AGENDA
BUDGET & FINANCE COMMITTEE MEETING
Tuesday, December 8, 2020 at 7:00 p.m.
N168 W20733 Main Street
Jackson, WI 53037

SECTION 00 63 63 CHANGE ORDER

Change Order No. 4

VILLAGE OF JACKSON
MUNICIPAL COMPLEX

DRAWING SHEET REF: ES100

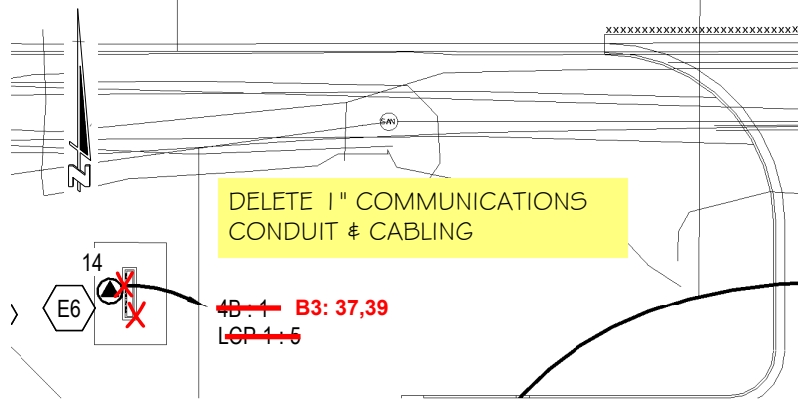
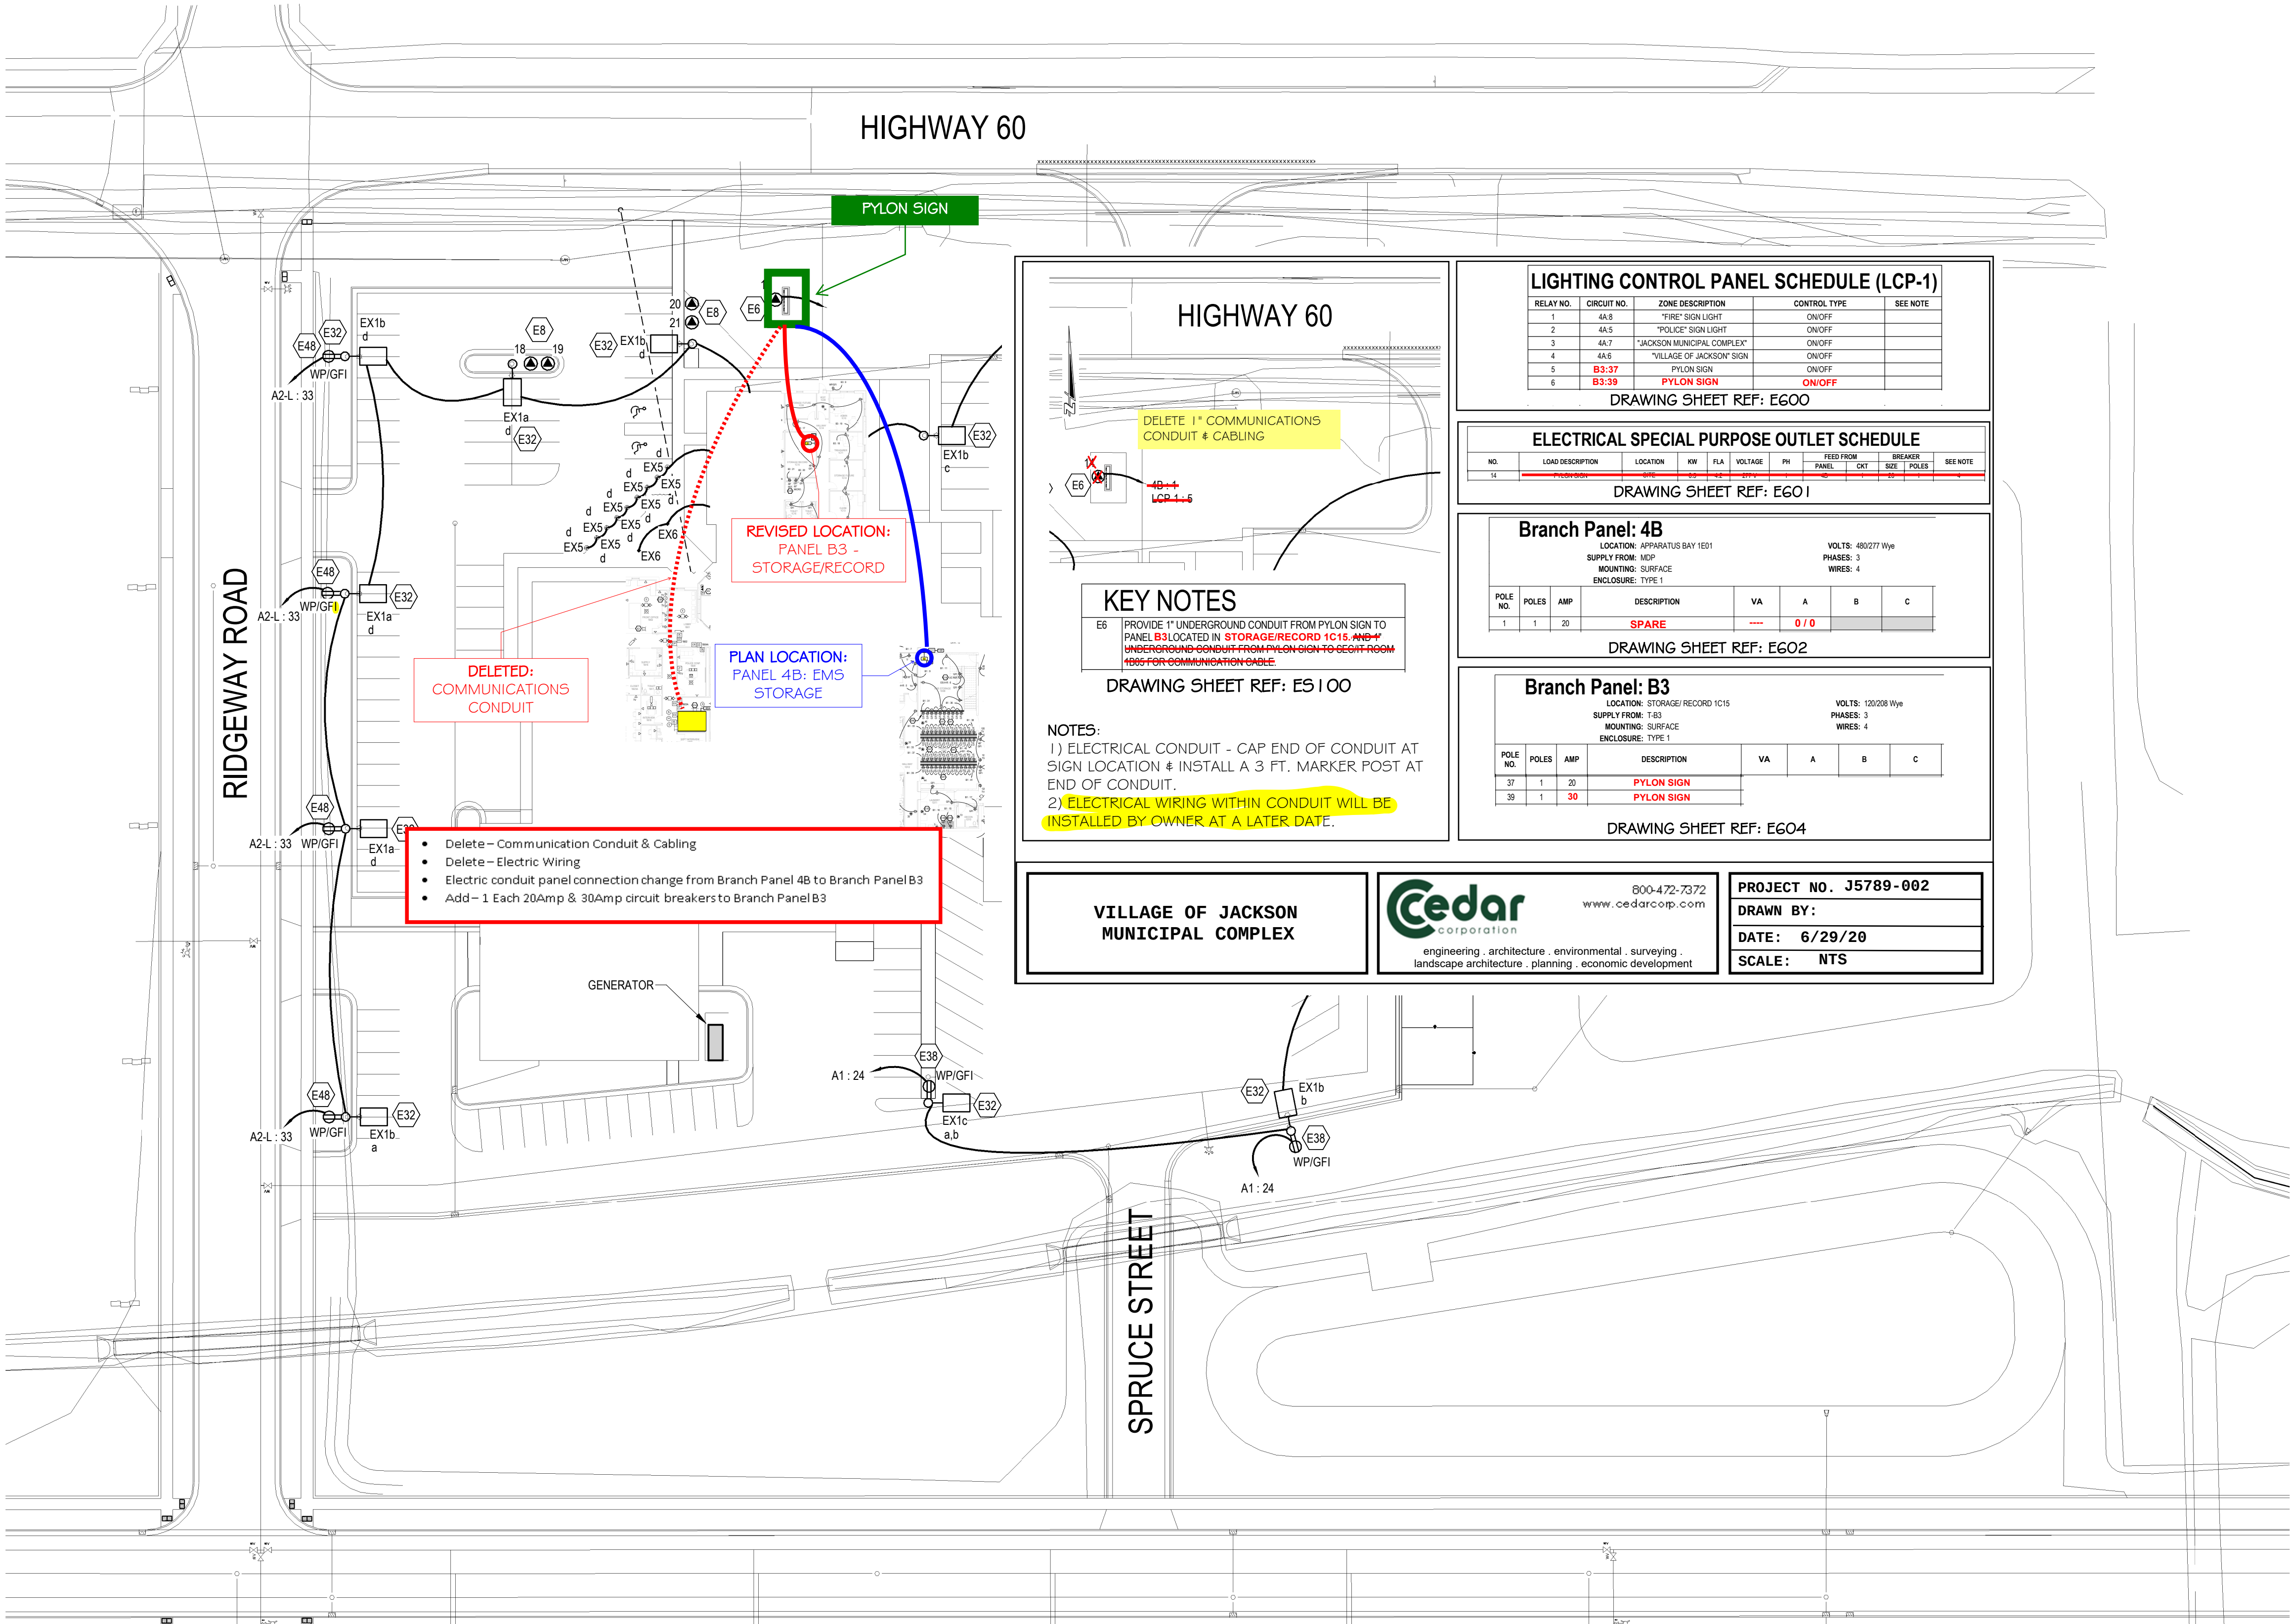
- a) Change Order Item No.1: Revisions to proposed communication and electric conduit number, lengths and locations based upon Owner's evaluation of needs and/or preferences for the proposed monument sign.

This conduit was already rough in to the building foundation. We just needed to extend it to its original location Per Drawing with the power conduit.

We interpreted sheet note E6 on the ES100 drawing dated 3/02/20 as conduit rough in only. Sheet Note E6 reads "Provide 1" Underground Conduit from Pylon Sign to Panel 4B Located In EMS Storage 1D08 and 1" Underground Conduit from Pylon Sign to SEC/IT Room 1B05 For Communication Cable".

Sheet Note E46 on the same drawing specifically calls for "Run Direct Burial Gel Filled Cat 6 Cable for Camera in A 1" Conduit to inside Apparatus Bay..." hence our reasoning for not including any cabling for the Sign location.

- E6 PROVIDE 1" UNDERGROUND CONDUIT FROM PYLON SIGN TO PANEL B3 LOCATED IN **STORAGE/RECORD 1C15**. ~~AND 4" UNDERGROUND CONDUIT FROM PYLON SIGN TO SECUT ROOM 4B05 FOR COMMUNICATION CABLE.~~
- PROVIDE (2) 30 AMP RELAY INTERCONNECTED TO THE NETWORK LIGHTING CONTROL SYSTEM LOCATED ADJACENT TO PANEL BOARD B3 TO CONTROL CIRCUITS AS AN ON/OFF FUNCTION PER LIGHTING BASIS OF DESIGN. FOR THE 20 AMP CIRCUIT RUN #10 WIRES AND FOR THE 30 AMP CURCUIT RUN #8 WIRES BOTH IN A 1" CONDUIT**

**Village of Jackson
Municipal Complex
Elevator Shaft Revision**

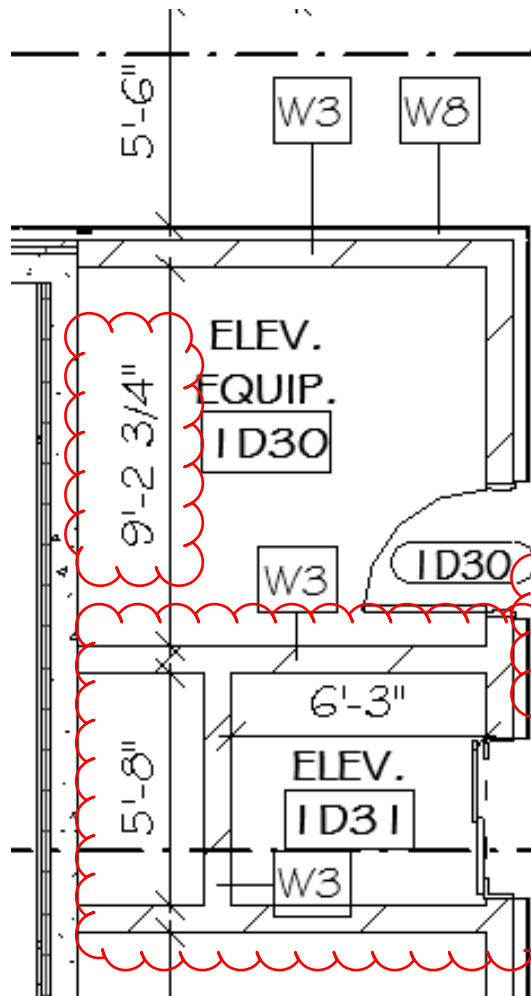
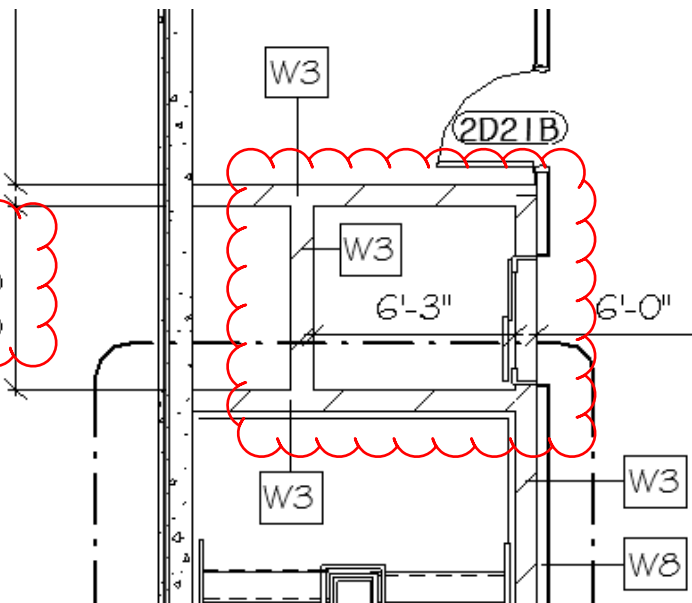
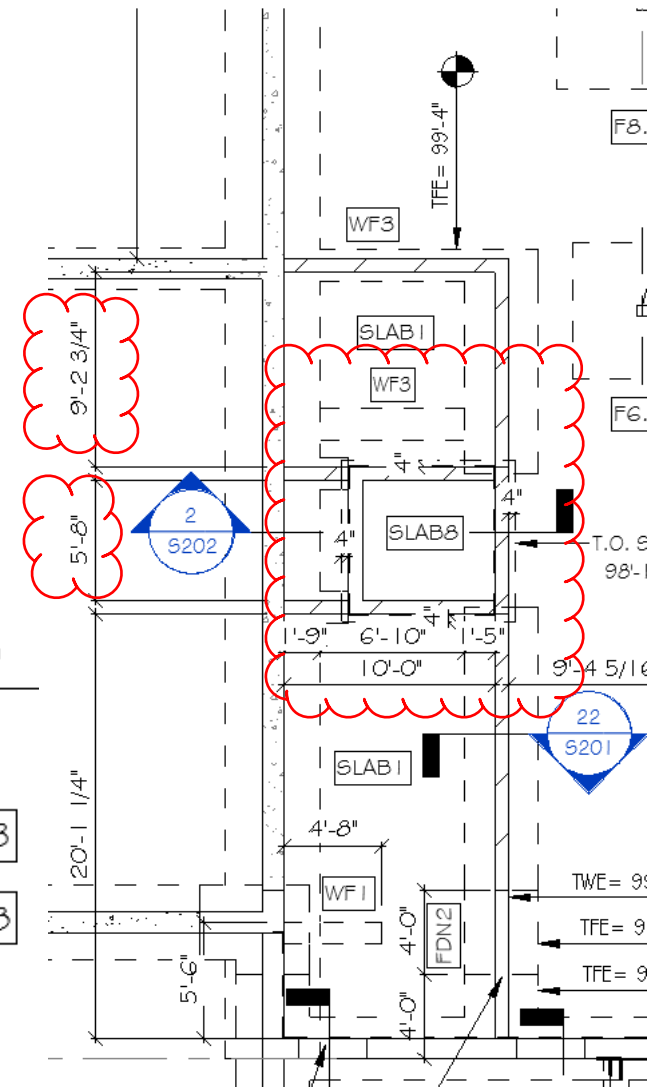
- b) Change Order Item No. 2: Based upon Contractor's elevator shop drawing submittal, required size of equipment required a revision of shaft size resulting in relocation of proposed shaft walls/wall foundations.

Mike Koenig Construction Co. Inc. proposes to supply labor, materials and equipment to complete the elevator shaft revisions per the drawing revision provided on 9-1-20 and per the following specifications.

- Saw cut and remove foundations already installed
- Add CMU wall on west side of shaft per drawing
- Extend second floor metal deck and concrete topping

- Remove current foundations at east and south wall of elevator shaft
- Revise base slab dimensions
- Add CMU wall at west side for reduced elevator shaft size.
- Add second floor metal deck and concrete and steel angle at north wall of elevator shaft for deck bearing

PCO #15: Added Rip Rap

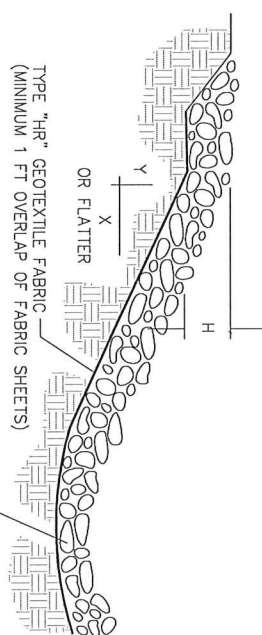
- c) Change Order Item No. 3: Re-evaluation of the building's roof drain pipe discharging within the storm water pond embankment, the volume of water could create create soil erosion. Therefore, rip rap material was installed from the point of pipe discharge to the pond's normal water elevation.

Mike Koenig Construction Co. Inc. proposes to supply labor, materials and equipment to complete provide and install rip rap at the roof drain outfall per drawing dated 10-6-20 and per the following specifications.
